#### **Amendment #1**

### 292 TREMONT STREET SITE IMPROVEMENTS 292 TREMONT STREET, ROCHESTER, N.Y. 14608 RHA Work Order #153248 / AECOM #60547770

August 21, 2017

CG-1

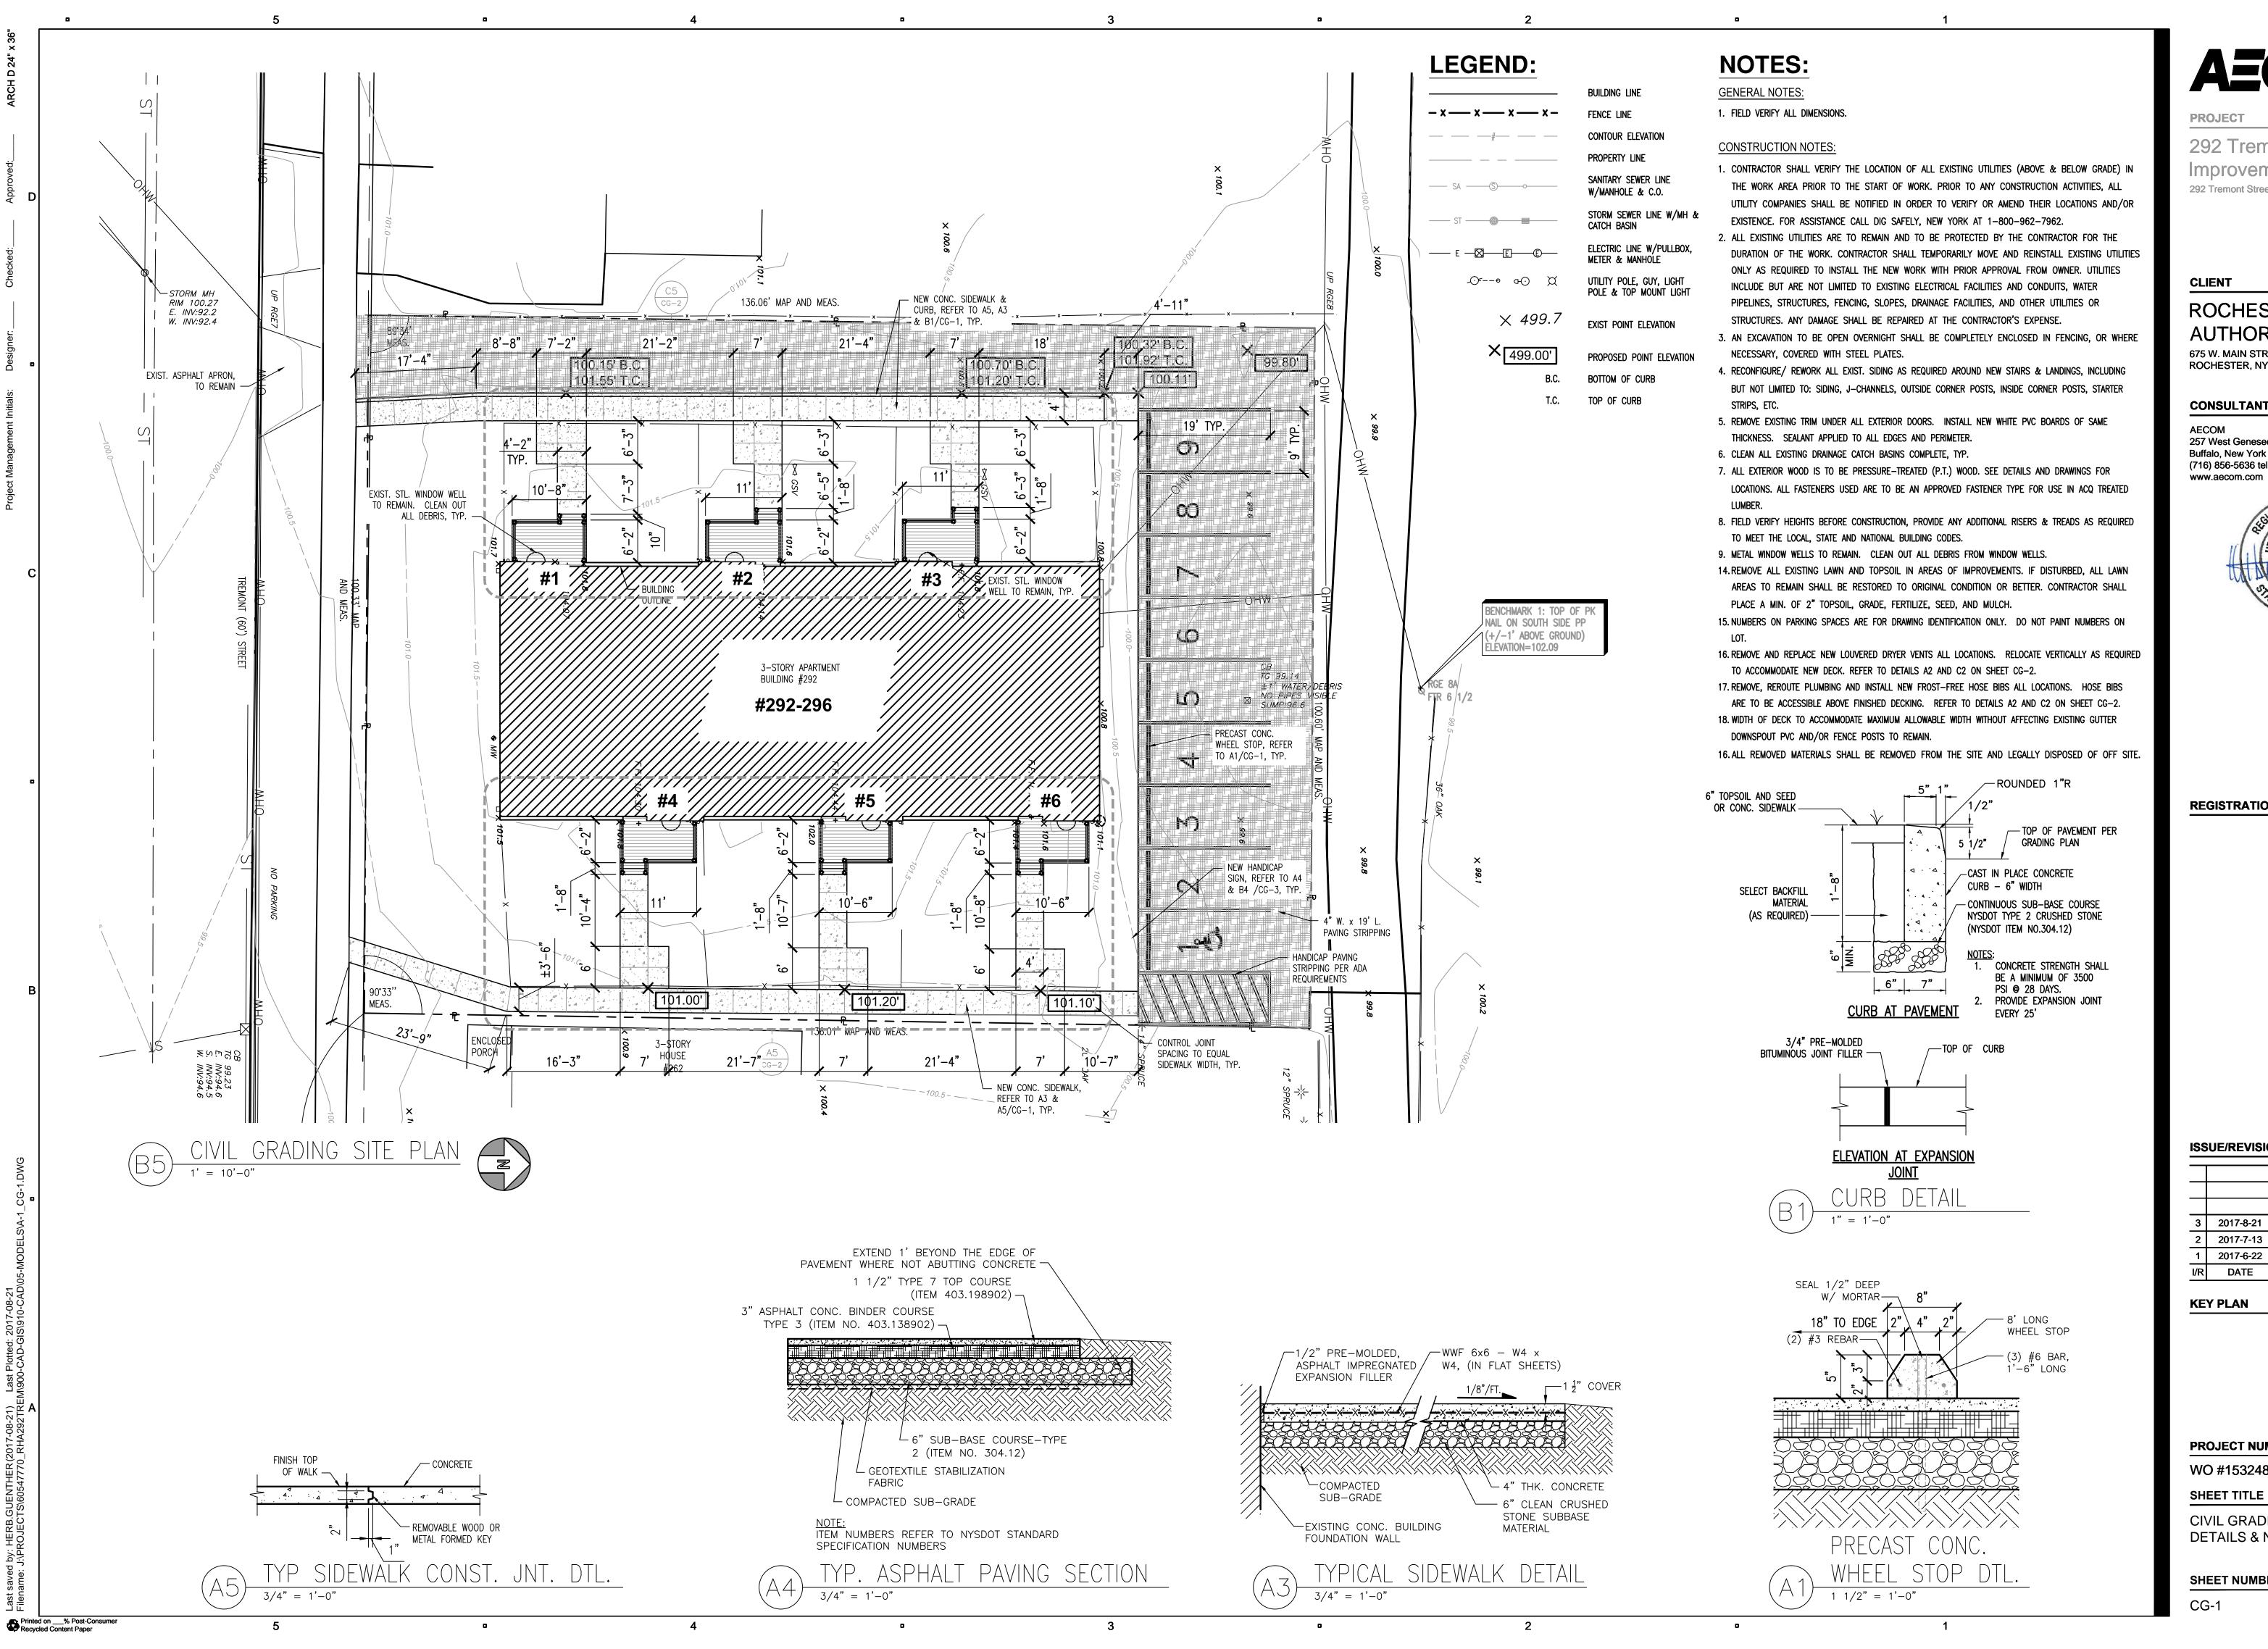
- 1. Drawing CG-1 has been reissued in its entirety. Point elevations, dimensions and detail B1 has been added to the drawing. Additional notes have also been added to the legend.
- 2. Geotextile Stabilization Fabric noted on detail A4 on drawing CG-1 shall be one of the following acceptable Manufacturers:
  - a. Phillips Fibers Corp., SUPAC 4NP.
  - b. WEBTEC, Inc. Terra Tex SD.
  - c. DuPont, Typar 3401.
  - d. Mirafi, 140N.
  - e. Exxon Chemical Co., GTF-130D.
  - f. Or approved equal
- 3. The header for page 3 for specification section 32 12 16 Asphalt Paving shall read:
